Access Compliance Report

Public Rights-of-Way

Intersection ID: 48942	Main Street: MITCHELL GRANT WY	Cross Street: MORGAN LEE AV	Location: S
ADA ID: C89CF9AFD75E	Ramp Type: Combination1	Initial Pass/Fail: Fail	Overall Compliance: No
Severity Score: 21.25			
Codes/Mitigation Info/Possible Solution		Field Measurements/Component Compliance

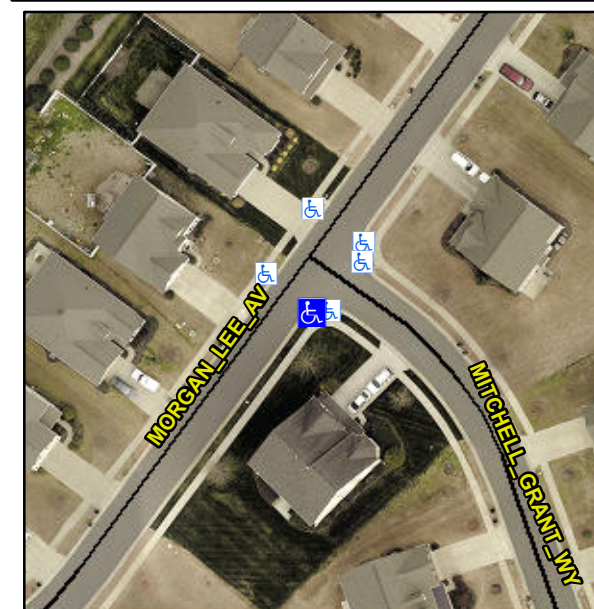
Not Found, R304.5.1, R304.5.1, R304.5.3

Compliance	Description	Data	Compliance	Description	Data
N/A	Ramp Length LT (in)	4.5	N/A	Ramp Length RT (in)	2.5
No	Ramp Width LT (in)	44.5	Yes	Ramp Width RT (in)	48.5
Yes	Ramp Slope LT (%)	6.2	Yes	Ramp Slope RT (%)	6.2
No	Ramp XSlope LT (%)	3.6	No	Ramp XSlope RT (%)	5.9
N/A	Ramp Length (in)	47.0	Yes	Ramp Slope (%)	6.3
No	Ramp Width (in)	47.0	No	Ramp XSlope (%)	5.8
N/A	Flare Type LT	N/A	N/A	Flare Type RT	N/A
N/A	Flare Slope LT (%)	N/A	N/A	Flare Slope RT (%)	N/A
N/A	Flare Traversable LT?	N/A	N/A	Flare Traversable RT?	N/A
N/A	Landing Length (in)	N/A	N/A	DWS Provided?	N/A
N/A	Landing Width (in)	N/A	N/A	DWS Contrast?	N/A
N/A	Landing Slope (%)	N/A	N/A	DWS Length (in)	N/A
N/A	Landing X Slope (%)	N/A	N/A	DWS Full Width?	N/A
N/A	Landing Curb? (Y/N)	N/A	N/A	DWS Offset (in)	N/A
N/A	Shared Landing?	N/A			
N/A	Gutter Ponding?	N/A	N/A	Gutter Slope (%)	N/A
N/A	Gutter Lip Ht (in)	N/A	N/A	Gutter X Slope (%)	N/A
N/A	Painted X Walk1?	No	N/A	Painted X Walk2?	N/A

Remove & Replace Entire Ramp.
